# COMAL COUNTY

### License to Operate On-Site Sewage Treatment and Disposal Facility

Issued This Date: 03/06/2025 Permit Number: 116271

### **Permit of Authorization to Construct an On-Site Sewage Facility Permit Valid For One Year From Date Issued**

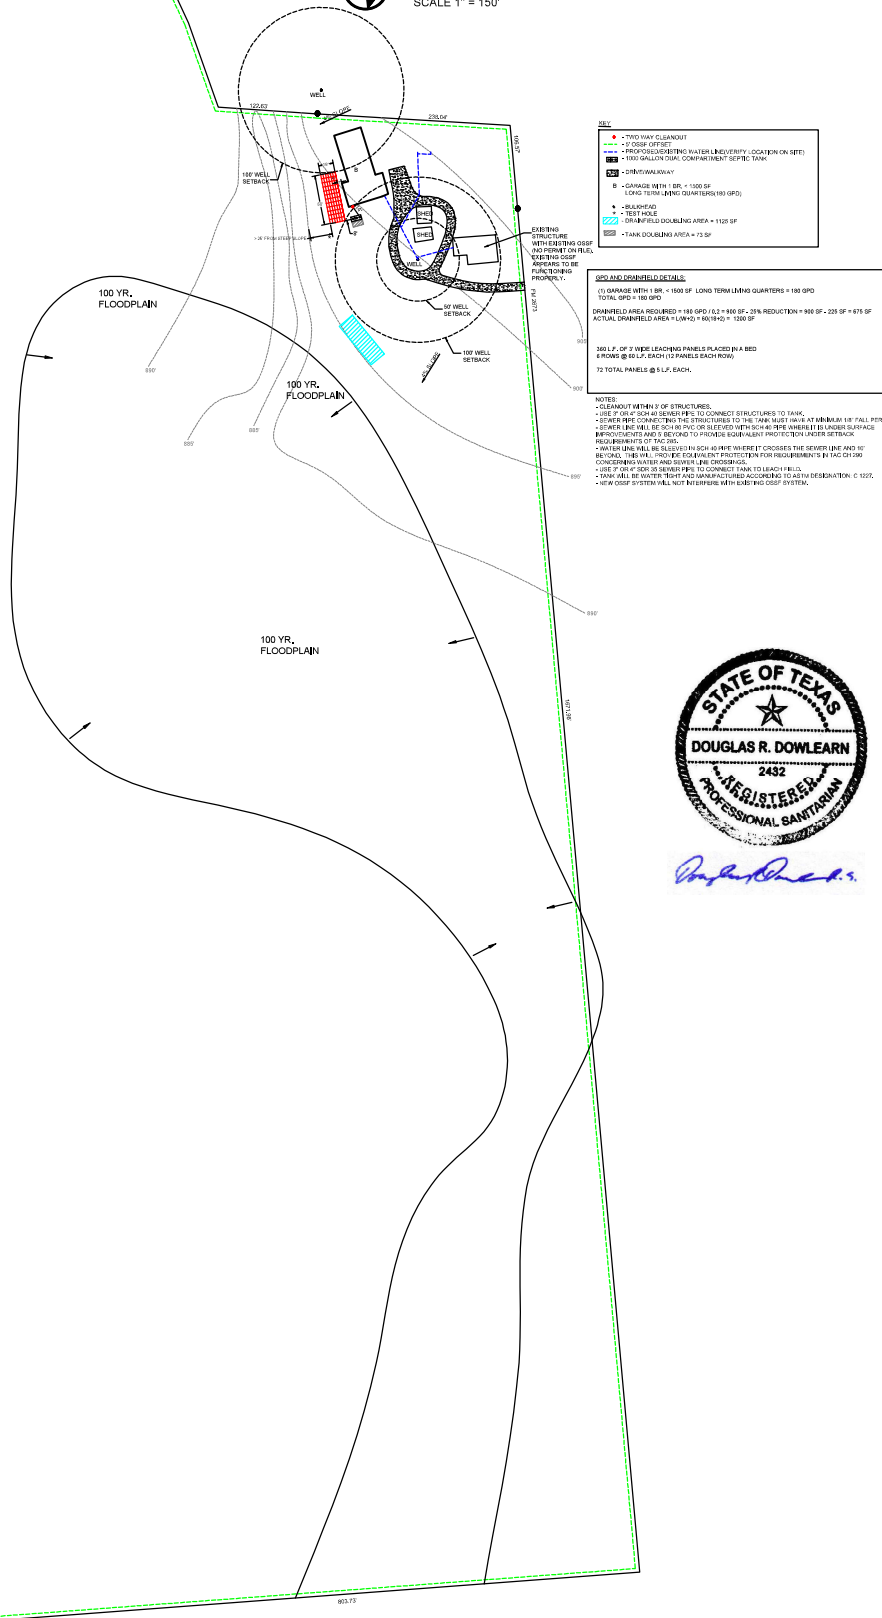
12/6/23 CA: System covered tightline to drive way good design to show sleeving under driveway and leave sleeving exposed to verify secondary structures not on sight will need to be on sight and connected before it to Waterline crossing is sleeved

3/6/25 CA: Revisions Received.

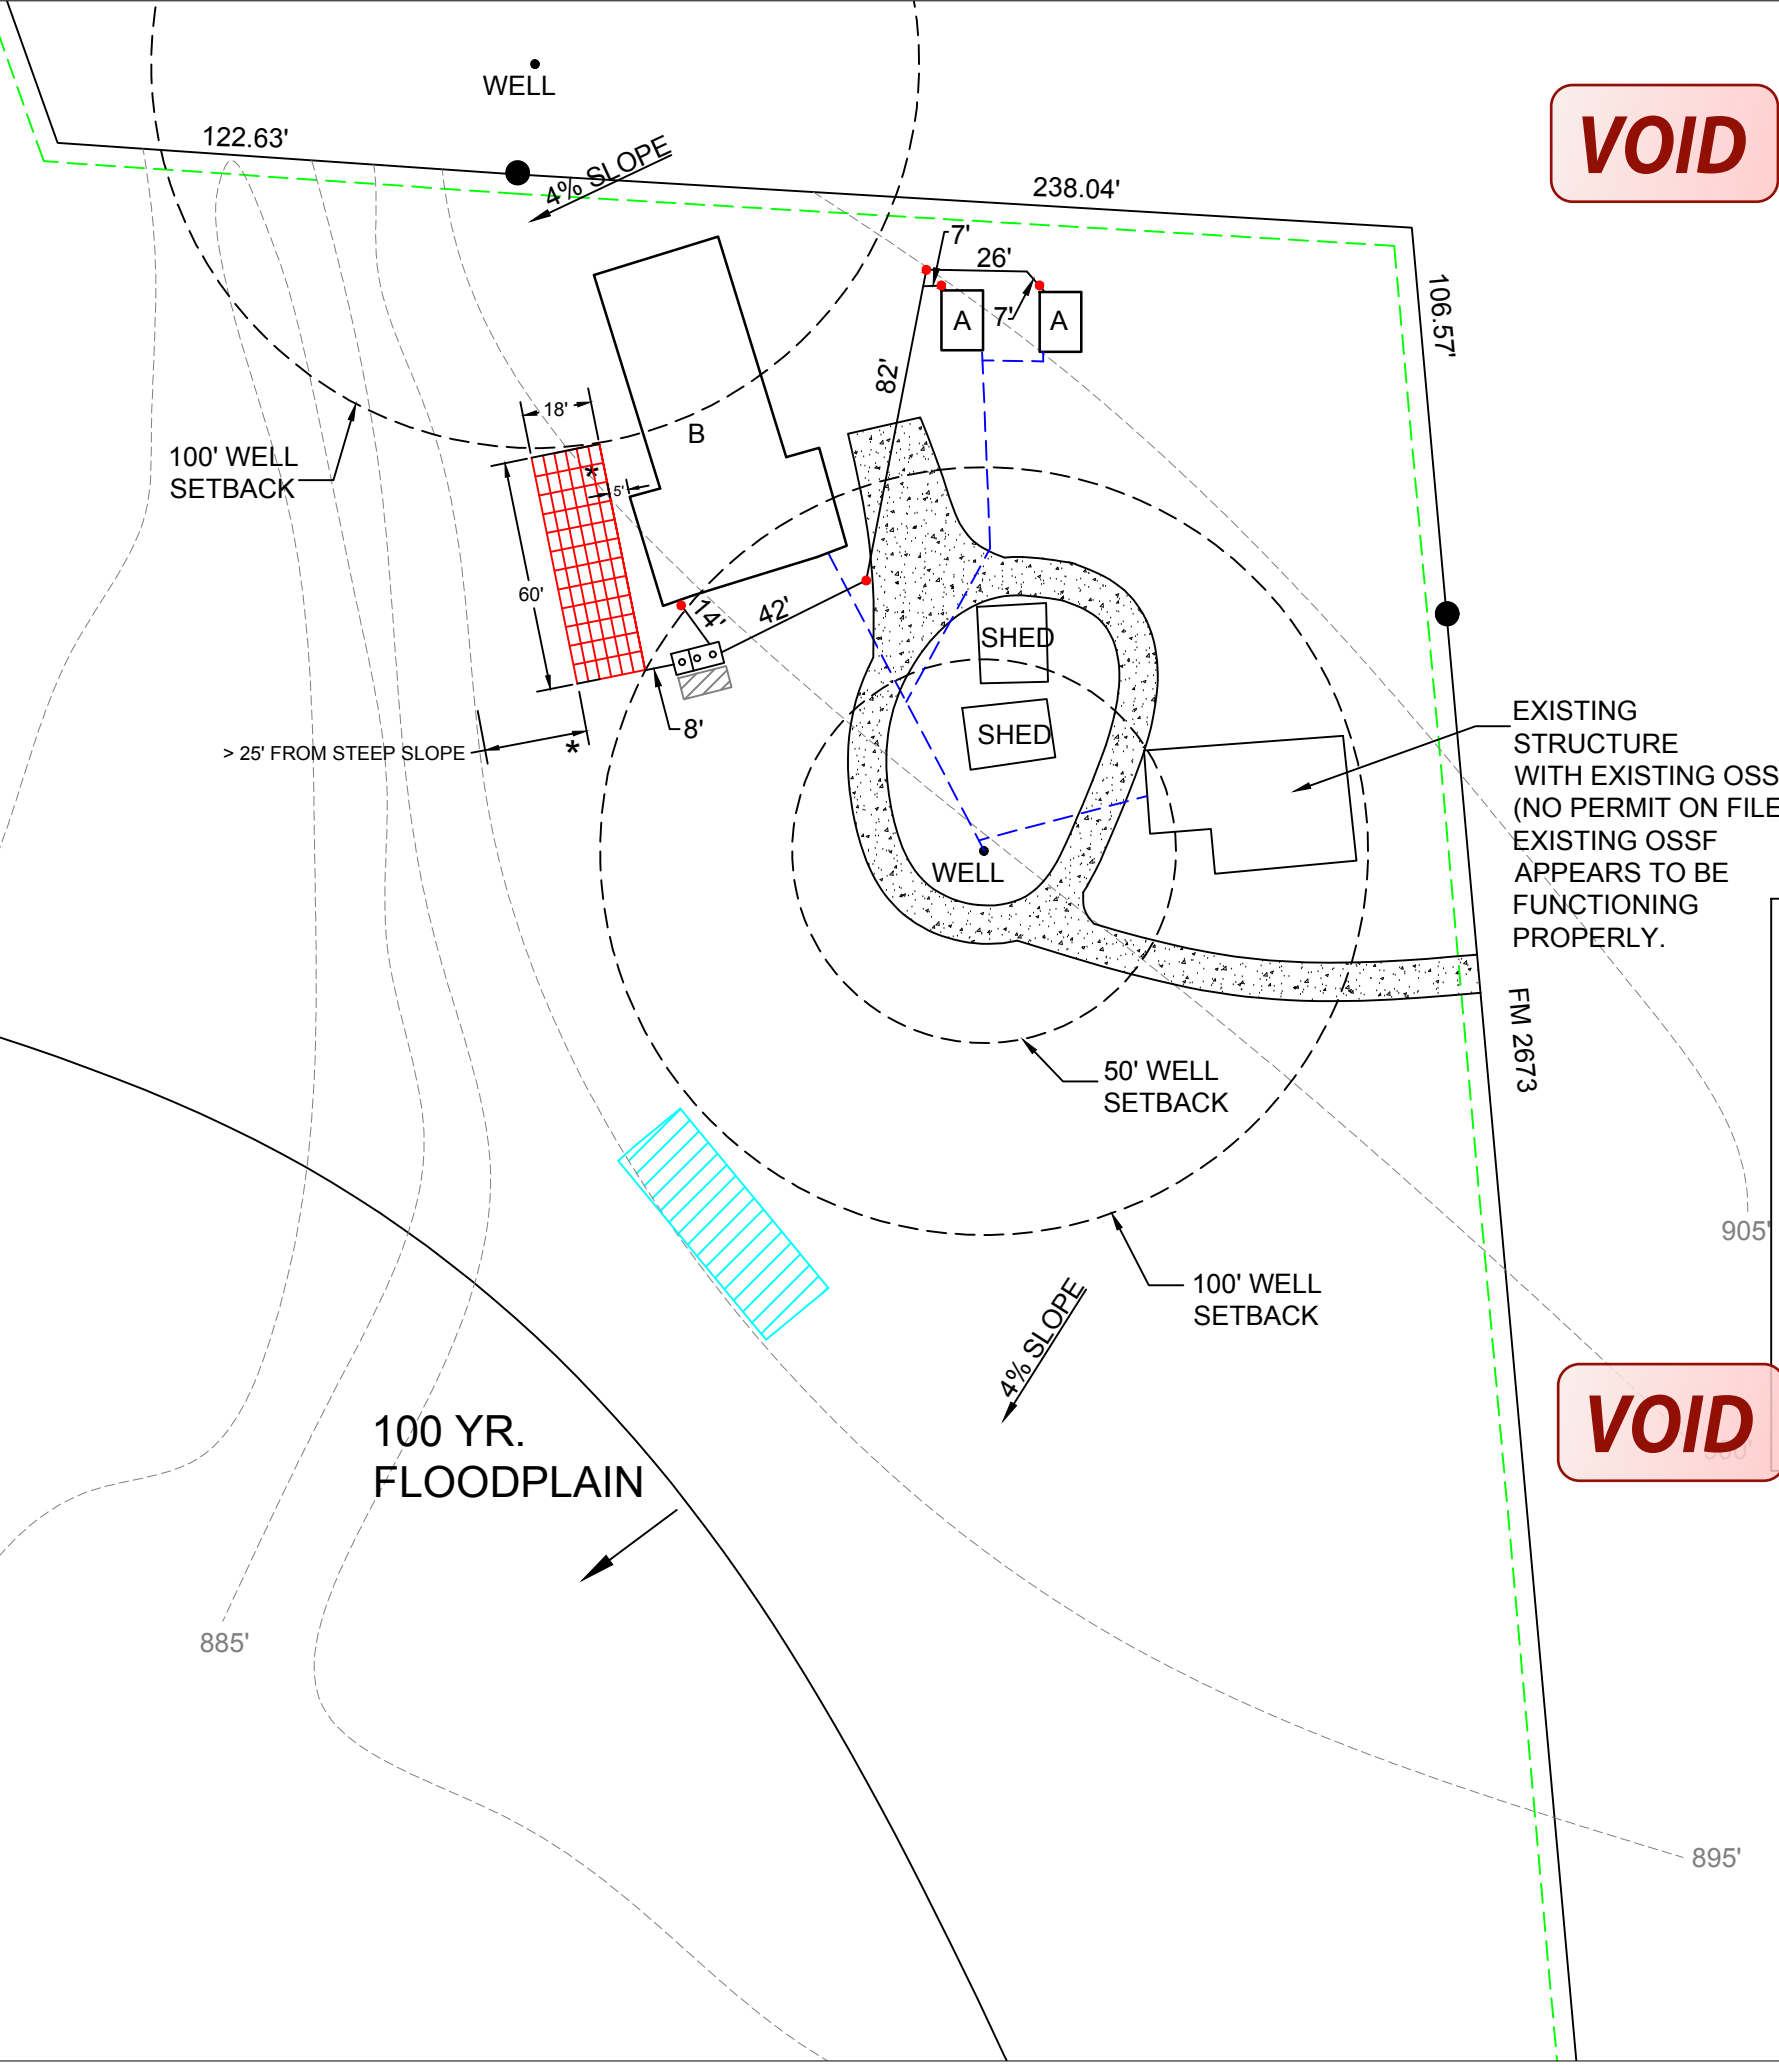
Good morning, please see attached revision removing the 2 cabins from the planning materials since they will be future structures.
